# RESPONSES TO COMMENTS ON THE DRAFT ENVIRONMENTAL IMPACT REPORT

## SFPUC Alameda Creek Recapture Project Volume 3

PLANNING DEPARTMENT  
CASE NO. 2015-004827ENV  
STATE CLEARINGHOUSE NO. 2015062072  
JUNE 7, 2017

Re: **Responses to Comments on the Draft Environmental Impact Report for  
Case No. 2015-004827ENV, SFPUC Alameda Creek Recapture Project**

**Figure 11.5-1**

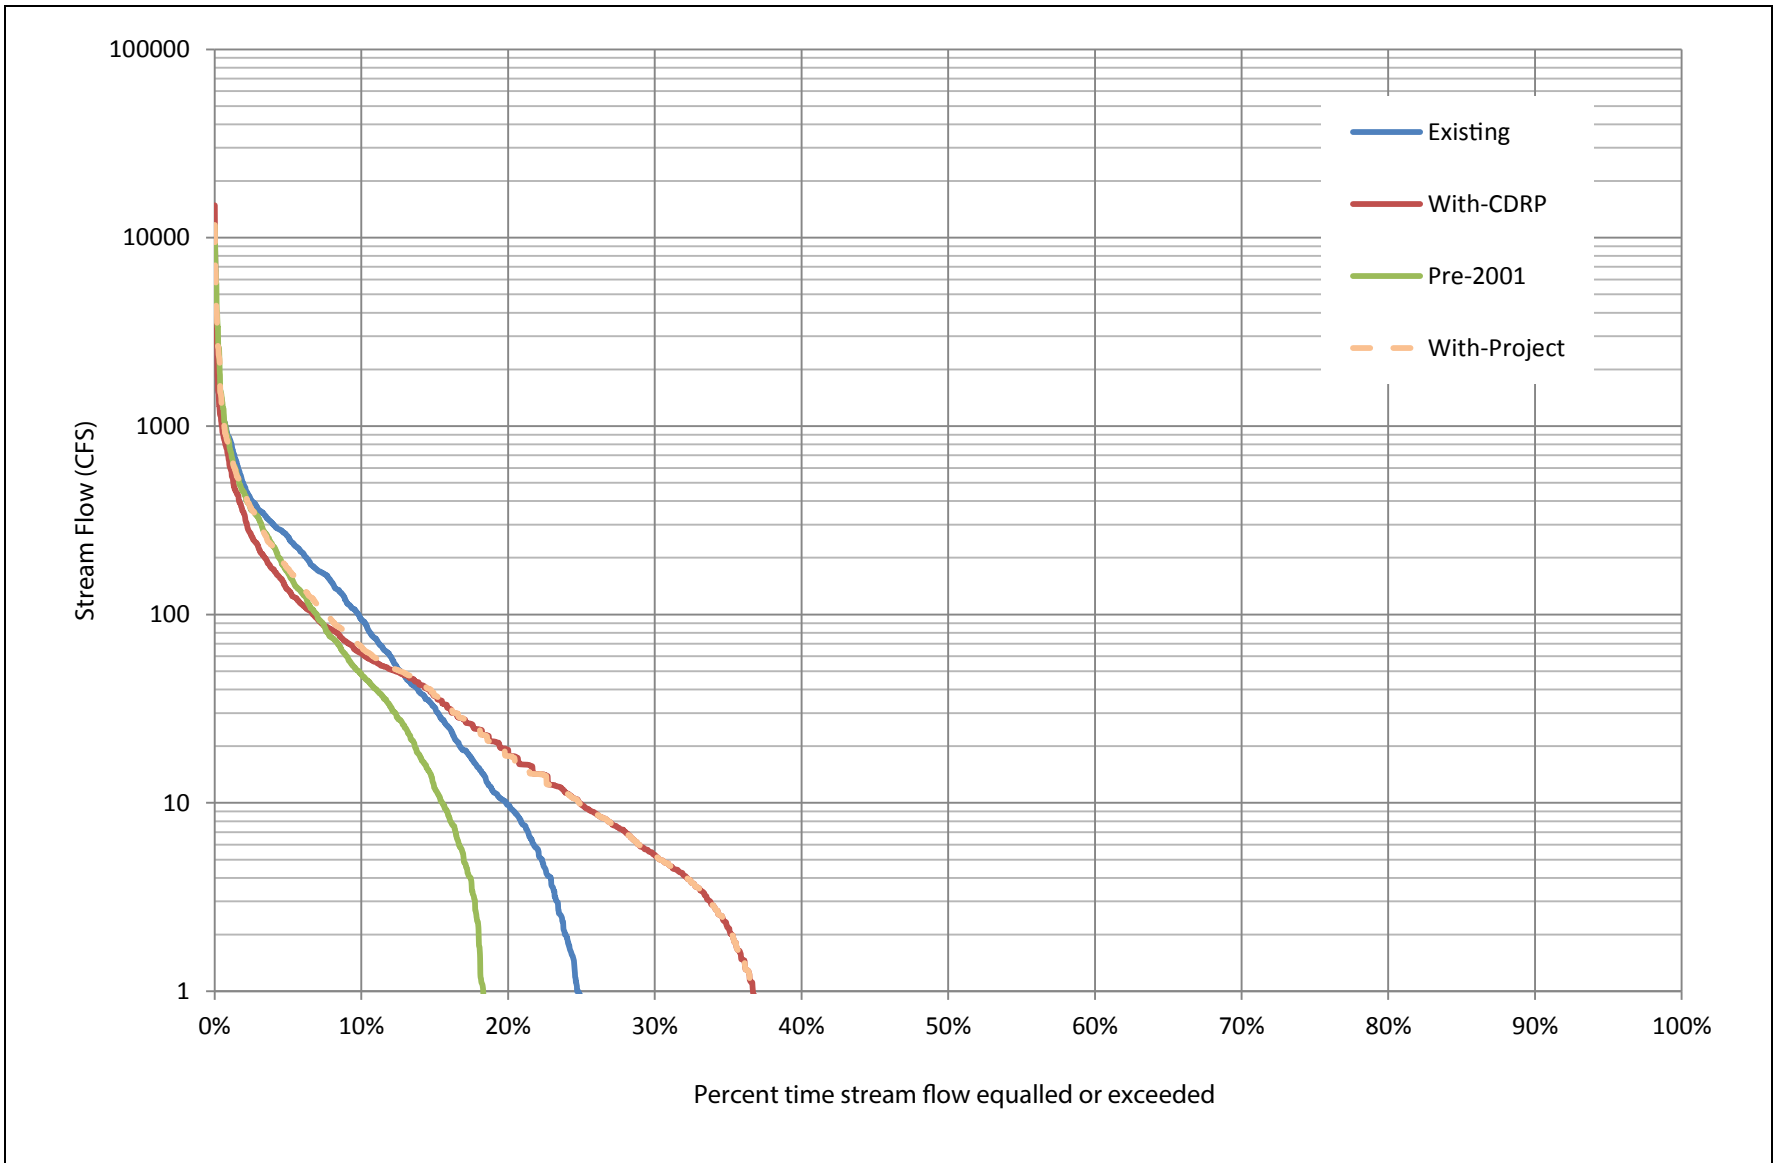
Comment A-NMFS-1 requests information on the number of days there is a surface water flow connection through the Sunol Valley to assist in assessing the ACRP’s potential effects on steelhead migration and the duration of flows for seasonal rearing of juvenile steelhead in the Sunol Valley. The number of days of surface water flow connection through Sunol Valley is not stated explicitly in the EIR but can be deduced from information provided in the EIR itself and Appendix HYD1 (Figures 5.16-3, 5.16-4, 5.16-5 in the EIR, pp. 5.16-13 to 5.16-16, and Section 5.16.2.4, pp. 5.16-11 to 5.16-18 in Chapter 5; and Section 5.3, pp. 61 to 76; and Section 5.3, pp. 61 to 76, Section 6.2, pp. 80 to 98, and Figures HYD5-5, HYD5-6, HYD5-7, HYD6-3, HYD6-4 and HYD6-5, pp. 63, 64, 66, 86 to 88, in Appendix HYD1). The results of the analysis of when there is a surface water connection through the Sunol Valley are shown in **Table 5.11-1**. For there to be continuous flow through Sunol Valley, there would need to be flow at both Nodes 5 and 7 on the same day, regardless of the flow at Node 4. An explanation of how the results were arrived at is provided below.

Figure HYD5-5 in Appendix HYD1 (p. 63) shows flow-duration curves for pre-2001 conditions, existing conditions, and with-CDRP conditions at the Alameda Creek/Welch Creek confluence (Node 4). **Figure 11.5-1** shows the same information, but with the addition of a flow-duration curve for with-project conditions. The figure shows that on about 52 percent of the days under pre-2001 conditions and on about 42 percent of the days under existing conditions, Alameda Creek is dry, or almost dry, at the Welch Creek confluence; or conversely, as indicated in Table 11.5-1, there would flow in the creek on 48 percent of the days under pre-2001 conditions, and 58 percent of the days under existing conditions. Under pre-2001 conditions, the SFPUC operated Calaveras Reservoir in accordance with the SFPUC's pre-1914 appropriative water rights and continues to do so under existing conditions. Under both with-CDRP and with-project conditions, flow would continue past the Welch Creek confluence every day and the creek channel would never be dry. This is a result of the releases at Calaveras Reservoir and the bypasses at the Alameda Creek Diversion Dam that are a part of with-CDRP and with-project conditions.

Figure HYD5-6 in the Appendix HYD1 (p. 64) shows flow-duration curves for pre-2001 conditions, existing conditions, and with-CDRP conditions at a location on Alameda Creek just upstream of the San Antonio Creek confluence (Node 5). **Figure 11.5-2** shows the same information, but with the addition of a flow-duration curve for with-project conditions. In all four scenarios, pre-2001 conditions, existing conditions, with-CDRP conditions, and with-project conditions, flow in Alameda Creek at the San Antonio Creek confluence is less than it is at the Welch Creek confluence. This is because the condition of the streambed of Alameda Creek under all four scenarios is made up of permeable gravels downstream of the Welch Creek confluence in the alluvial deposits of Sunol Valley. Project construction and operation will not change this condition. As a result, surface water is lost under existing conditions, and will continue to be lost under with-project conditions, to the subsurface between the Welch Creek and San Antonio Creek confluences at a maximum rate of 17 cubic feet per second (cfs). Under pre-2001 conditions, Alameda Creek just upstream of the San Antonio Creek confluence was dry, or almost dry, about 82 percent of the time; under existing conditions it is dry, or almost dry, about 75 percent of the time. Stated conversely, this portion of the channel has continuous flow 7 percent more often under existing conditions than under conditions before 2001 when the Calaveras Reservoir operated at full capacity, reflecting the inability of the SFPUC to fully utilize the entire storage volume of Calaveras Reservoir under the 2001 DSOD order. Under with-CDRP and with-project conditions, the creek would be dry, or almost dry, about 64 percent of the time. Thus, in the reach of Alameda Creek upstream of the San Antonio Creek confluence, continuous flow occurred about 18 percent of the time under pre-2001 conditions, under existing conditions it occurs about 25 percent, of the time, and under with-CDRP and with-project conditions it would occur about 36 percent of the time.

SFPUC Alameda Creek Recapture Project  
**Revised Figure 1-1**  
 Project Vicinity Map

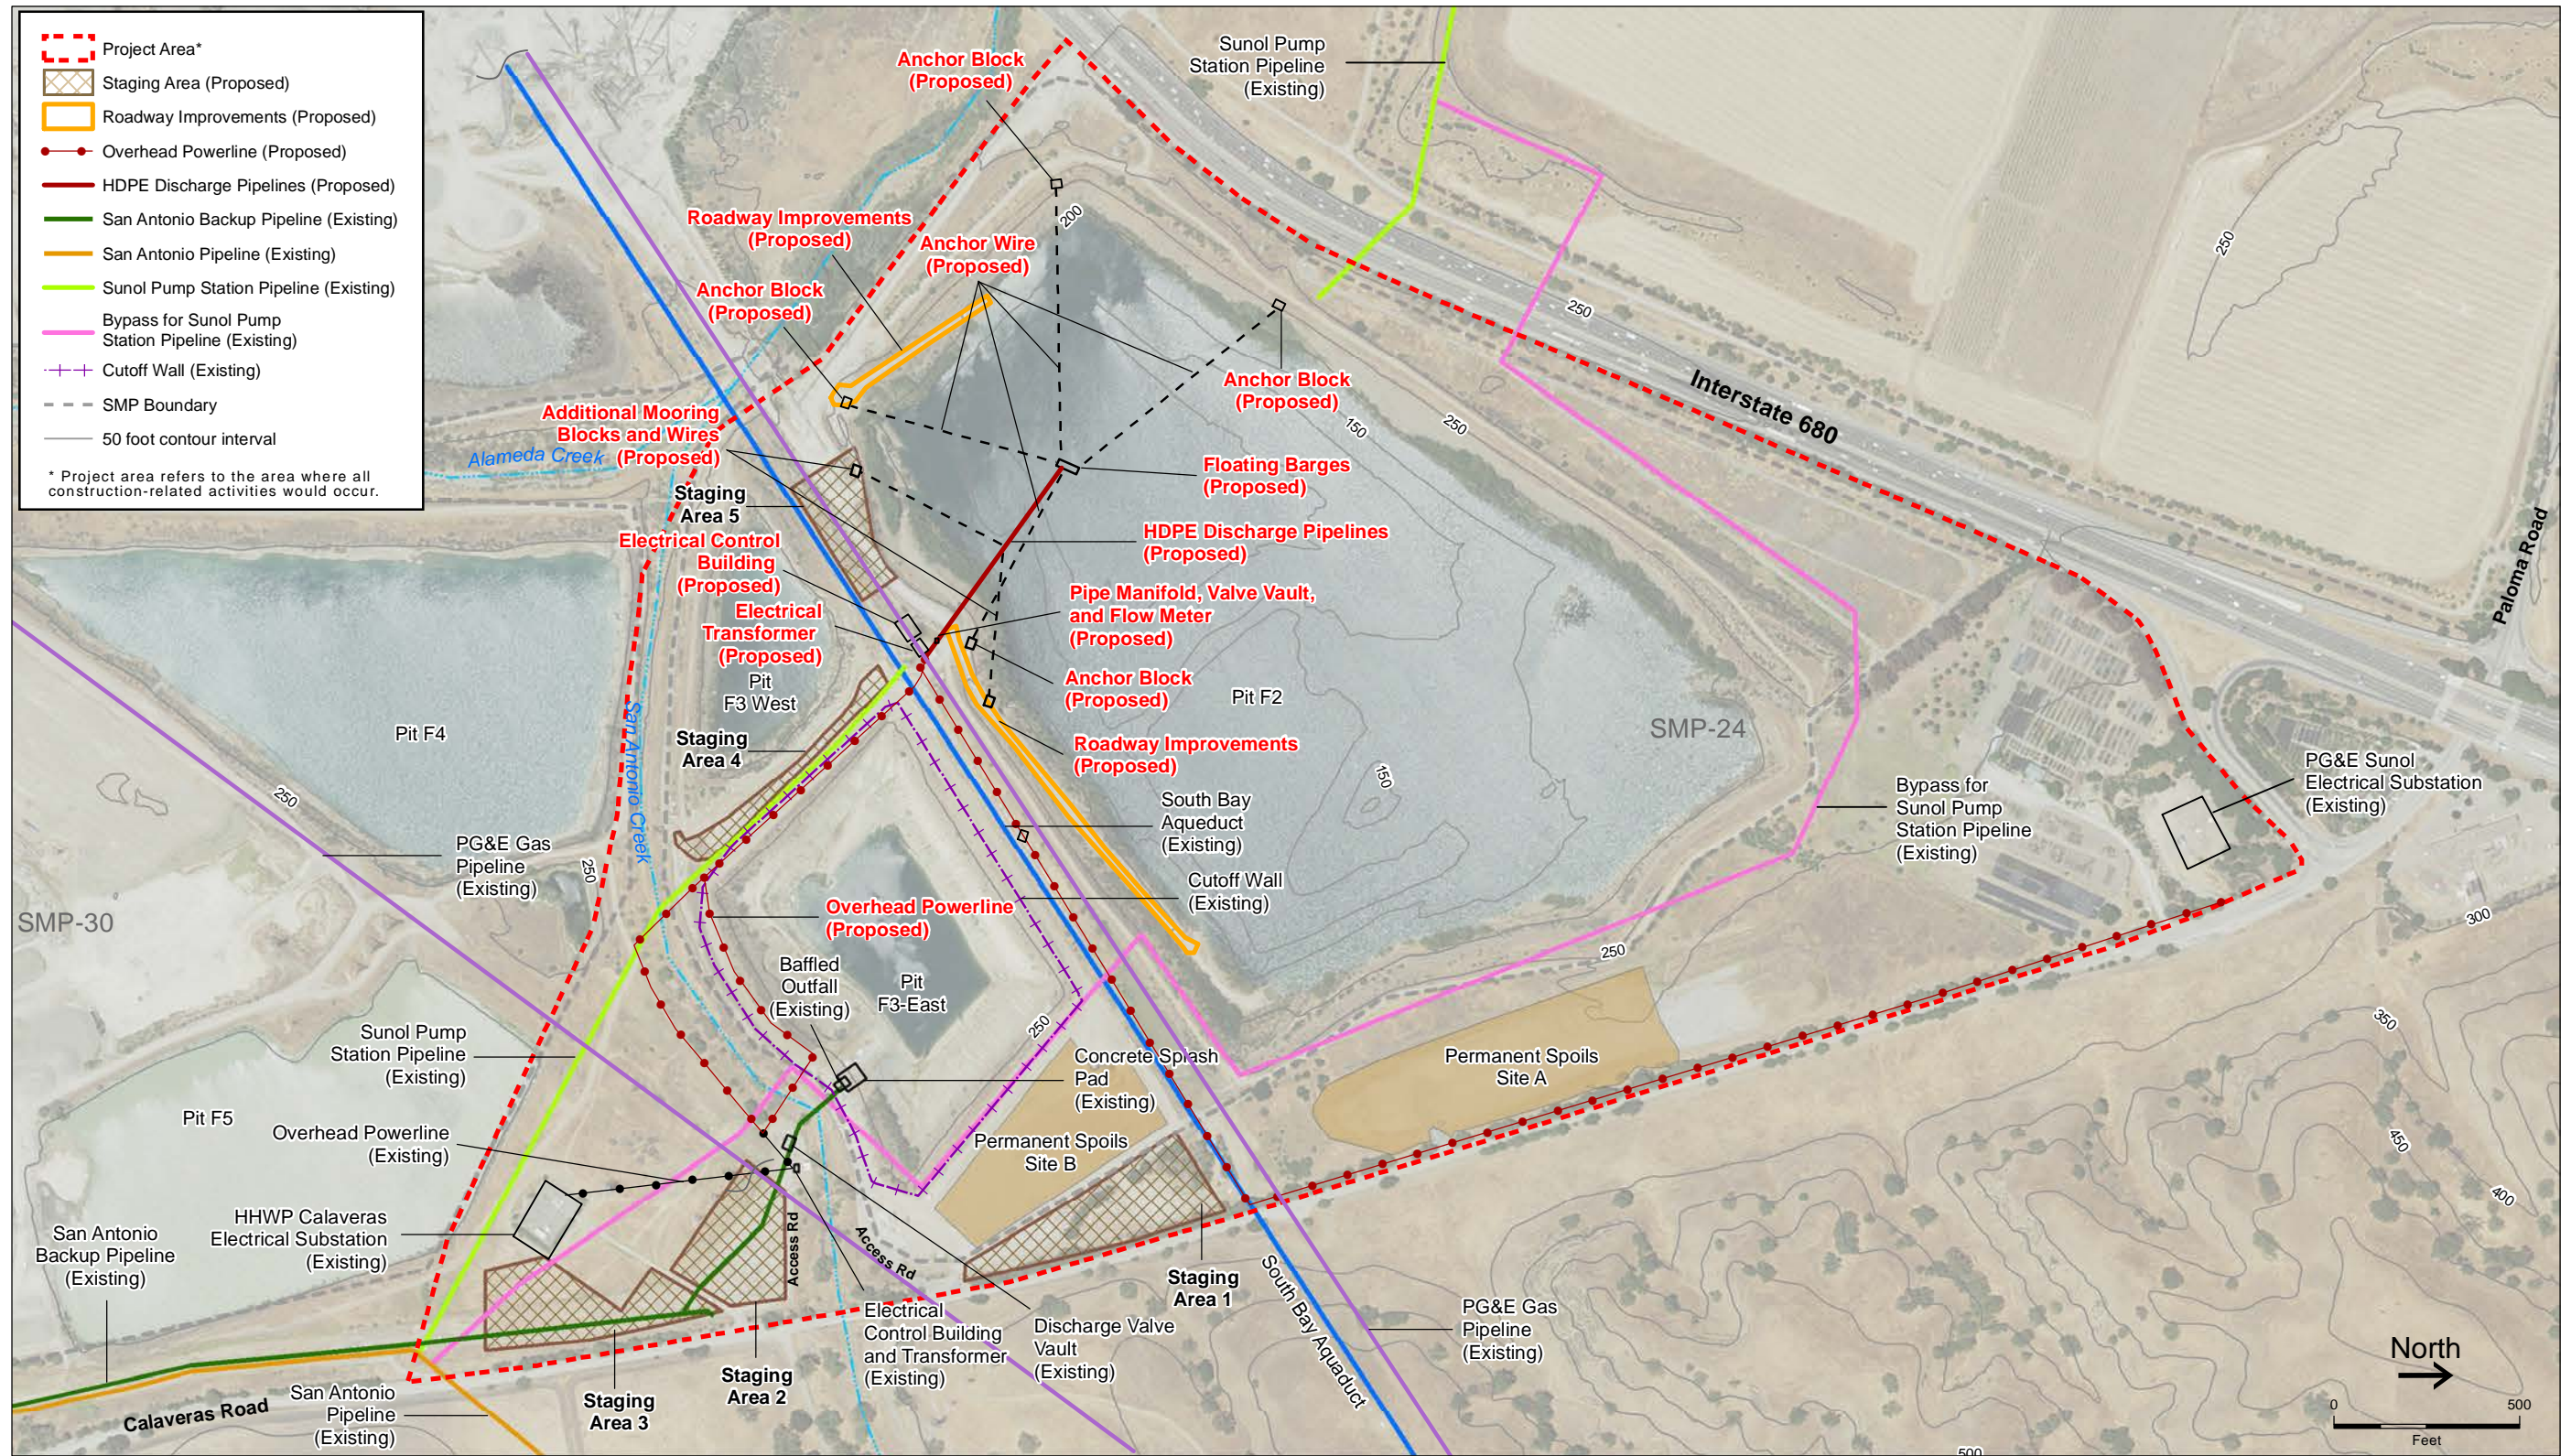
f. **The DEIR cumulative impacts do not include effects of cutoff walls.** Figure 1-1 of the DEIR displays existing cutoff walls around Pit F2, which were installed to minimize seepage of Alameda Creek surface water into the groundwater basin and into Pit F2. The figure also displays proposed future cutoff walls around sections of Pit F6. Installation of this future cutoff wall will likely provide additional protection from surface streamflow losses to the Sunol groundwater basin. The hydrologic analysis must be refined to include the proposed cutoff wall, and any associated changes in streamflow loss rate to determine cumulative impacts and adequately model future streamflow conditions through this reach (CEQA Guidelines §§ 15065(a)(3), 15130). (Robert Shaver, General Manager, Alameda County Water District, January 30, 2017, A-ACWD2-10)

- 1.) In Figure 1-1 of the DEIR, it appears that surface water flow originating from rainfall has the ability to run directly into Pit F2. Former nurseries are located immediately adjacent to the north and south of Pit F2. The DEIR must include a comprehensive analysis and assessment at this location to ensure that surface soil is not contaminated in the vicinity of Pit F2. Contaminated surface soil could impact the water quality of surface runoff to Pit F2.

In response to this comment, Figure 1-1 and Figure 3-2 in the EIR (identical figures) have been revised to remove the proposed cutoff wall because it currently does not exist. This revision does not change the analysis or conclusions of the EIR.

As discussed in Response HY-9, Figure 1-1, page 1-3 has been revised to remove the proposed cutoff wall because it currently does not exist, as shown on page 12-3. See Revised Figure 1-1.
